July 19, 2005
9704-PFS-107

Enclosures: GT STRUDL Program Report Forms 2005.02 – 2005.04

GTSTRUDL Program Report Form

GPRF No.: 2005.02

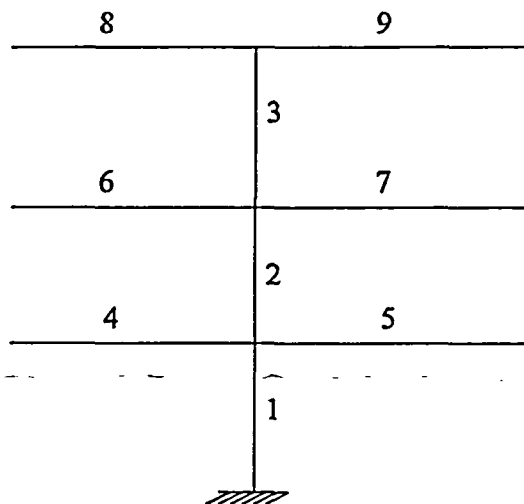
Automatic K-factor computations will be incorrect if the user specifies parameter FRLY or FRLZ for the beams or columns connected to the member for which the K-factor is being computed.

COLUMN LINE 'COL1' MEMBERS 1 TO 3

FRLY	0.5	MEMBERS 4 TO 9
COMP	KZ	MEMBERS 1 TO 3

Specify the parameters LY and LZ for the unbraced length. Do not use FRLY and FRLZ when requesting the automatic K-factor computation.
